Six Chuter International LLC

SERVICE BULLETIN 2013-02

LEVEL	ADVISORY
DATE	08/01/2013
SB NUMBER	Service Bulletin 2013-02
APPLICABLE MODELS & CATEGORIES	All Legend Models (XL, Paragon, 103s)

1.4) Subject
Inspection, maintenance or replacement of Front Fork Parts

AFFECTED INSTALLATION & PARTS

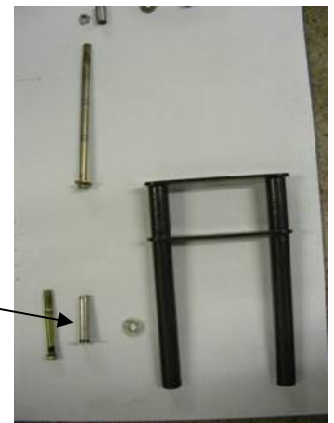
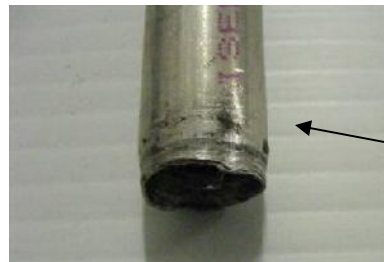
We have had a total of six reported maintenance issues on Legend XL front forks. These have been on both the heavier fork for 912 and the standard one. The aluminum insert for the bolt that connects the fork to the frame rail has been found to wear excessively. Once worn the bolt tends to enlarge the hole resulting in wobbling movement of the front fork. These reports are from owners of Legend powered parachutes that are flown from rougher fields, or are heavy use aircraft (training) and other high hour uses.

1.5.2 If excessive play is discovered with this installation the front fork and end plate on the frame plate should be removed to check the aluminum insert for deformity.

1.5.3 If there is any deformation to the aluminum insert, or if the holes that hold the front fork bolt are showing signs of deformity, then this new installation is recommended.

2.3 Material required per Aircraft Two ¾" Brass Bushing with 5/8" inside diameter

3.1 Order replacement parts, Brass Bushing. Carefully drill out the ¼" hole to accommodate installation of brass bushings on top side and underside of fork. Replace the front fork. Eliminate the aluminum insert and secure the end plate of the frame rail.
